**SOLICITATION AMENDMENT**  
**MODIFICATION DE L'INVITATION**

<b>Title - Sujet</b> JAG Boiler Replacement	
<b>Solicitation No. - N° de l'invitation</b> E0226-210391/A	<b>Amendment No. - N° modif.</b> 002
<b>Client Reference No. - N° de référence du client</b> E0226-210391	<b>Date</b> 2020-07-13
<b>GETS Reference No. - N° de référence de SEAG</b> PW-SPWC-033-4506	
<b>File No. - N° de dossier</b> PWC-0-43014 (033)	<b>CCC No./N° CCC - FMS No./N° VME</b>
<b>Solicitation Closes - L'invitation prend fin</b> <b>at - à 02:00 PM</b> <b>on - le 2020-07-28</b>	
<b>F.O.B. - F.A.B.</b> <b>Plant-Usine:</b> <input type="checkbox"/> <b>Destination:</b> <input checked="" type="checkbox"/> <b>Other-Autre:</b> <input type="checkbox"/>	
<b>Address Enquiries to: - Adresser toutes questions à:</b> Young (PWC), Leesa	<b>Buyer Id - Id de l'acheteur</b> pwc033
<b>Telephone No. - N° de téléphone</b> (506) 871-1716 ( )	<b>FAX No. - N° de FAX</b> (506) 851-6759
<b>Destination - of Goods, Services, and Construction:</b> <b>Destination - des biens, services et construction:</b>

Addendum No. 002.

(MSK-01)-MSK01 R.087314.002 JAG Boiler Replacement (MSK-01)-MSK01.  
Revised boiler stack locations and required piping relocations.

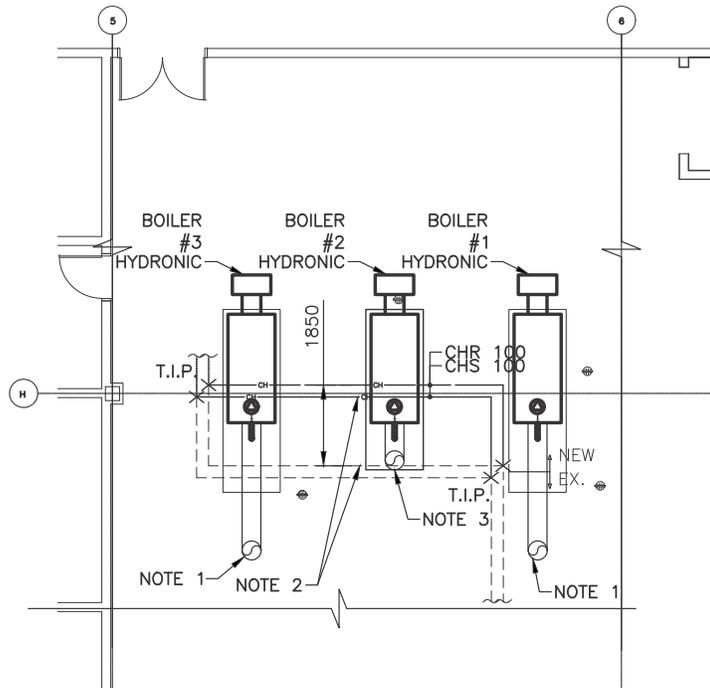
**Question 7:** We did the calculations for the venting on the above noted project and the calculated chimney is 16", not 12" as per the drawings. This calculation is based on the boiler capacity, fuel, combustion characteristic, and dimensional information – so it wouldn't matter what manufacturer of boiler or venting system. Historically the specifications will specify the contractor is to verify this information and shop drawing approval would include calculations from the venting manufacturer and approval by the boiler supplier.

With reference to Drawing H3

**Add** new detail:

## NEW BOILER STACK PLAN

1. REUSE EXISTING BOILER EXHAUST STACK LOCATIONS FOR NEW HYDRONIC BOILERS #1 & 3 EXHAUST STACKS. PROVIDE FOR THE REPLACEMENT AND REPAIR OF INSULATION, ROOF MATERIAL, ETC. AS REQUIRED TO ACCOMMODATE THE INSTALLATION.
2. PROVIDE FOR THE RELOCATION OF EXISTING, SUSPENDED CHILLED WATER LINES, AS INDICATED ON DRAWING, TO SUFFICIENTLY ACCOMMODATE THE INSTALLATION OF A NEW BOILER EXHAUST STACK FOR HYDRONIC BOILER #2.
3. NEW HYDRONIC BOILER #2 EXHAUST STACK TO PENETRATE THROUGH ROOF IN SPACE CLEARED BY THE RELOCATION OF TREATED WATER BACKFLOW PREVENTERS.
